TECHNICAL BULLETIN

[Issue No.] GOT-A-0096-A

[Title] GOT2000 Series Wireless LAN Communication Unit (GT25-WLAN) Complies with Overseas Radio Laws and Regulations

[Date of Issue] May 2016 (Ver. A: May 2017)

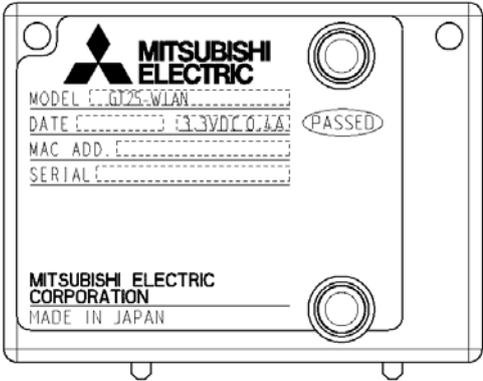
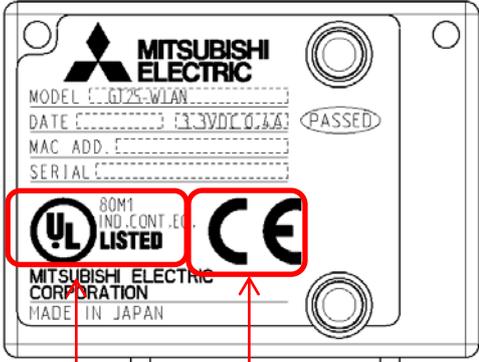
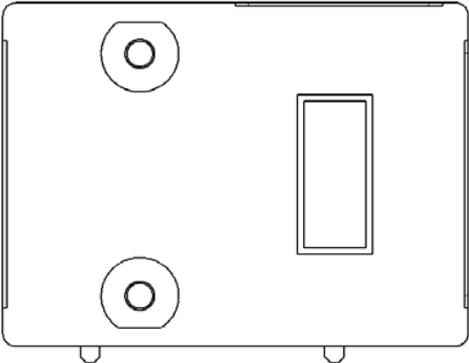
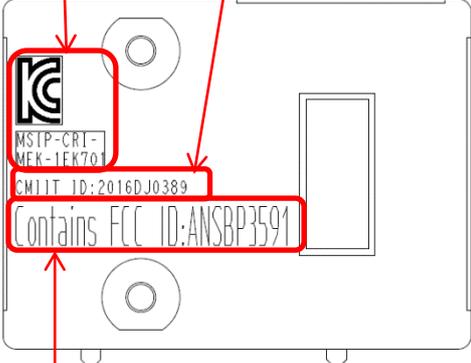
We have changed the descriptions on the rating plate, product, and packaging label accordingly for overseas use.

Item	Before change	After change
Rating plate	 <p>The rating plate shows the Mitsubishi Electric logo, model number GT25-WLAN, date 13/3YD/C/0/AA, MAC address, and serial number. It also features a 'PASSED' stamp and the text 'MITSUBISHI ELECTRIC CORPORATION MADE IN JAPAN'.</p>	 <p>The rating plate after change includes the same information as before but adds a UL mark (UL 80M1 IND. CONT. EQ. LISTED) and a CE mark (RE Directive, R&TTE Directive) highlighted in red. The text 'MITSUBISHI ELECTRIC CORPORATION MADE IN JAPAN' remains.</p> <p>UL mark CE mark (RE Directive, R&TTE Directive)</p>
Product (Extension connector side)	 <p>The product view shows the extension connector side with two circular ports and a rectangular slot.</p>	 <p>The product view after change shows the addition of a KC mark (highlighted in red), a CMIIT ID No. (2016DJ0389, highlighted in red), and the text 'Contains FCC ID: ANSBP3591' (highlighted in red). The FCC No. is also indicated.</p> <p>KC mark CMIIT ID No. (SRRC requirements)</p> <p>FCC No.</p>

Item	Before change	After change
Packaging label

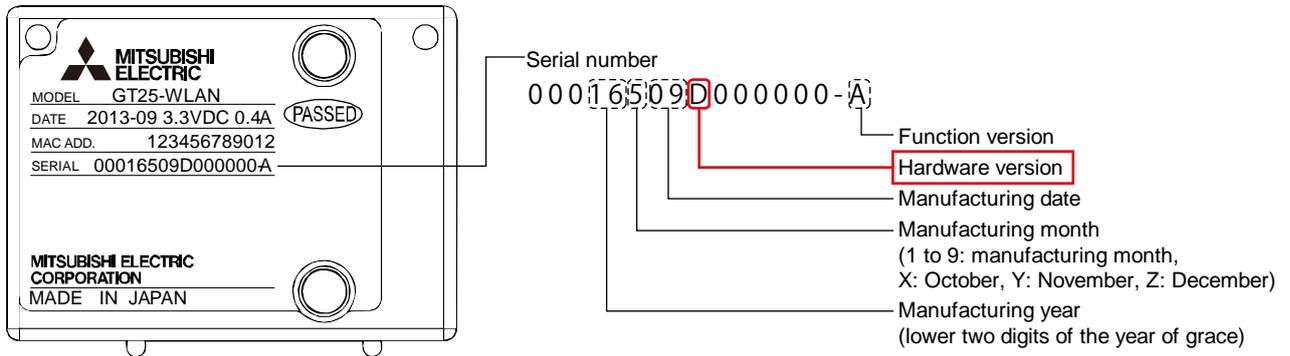
The descriptions on the rating plate, product, and packaging label are changed along with the compliance with the overseas radio laws and regulations.
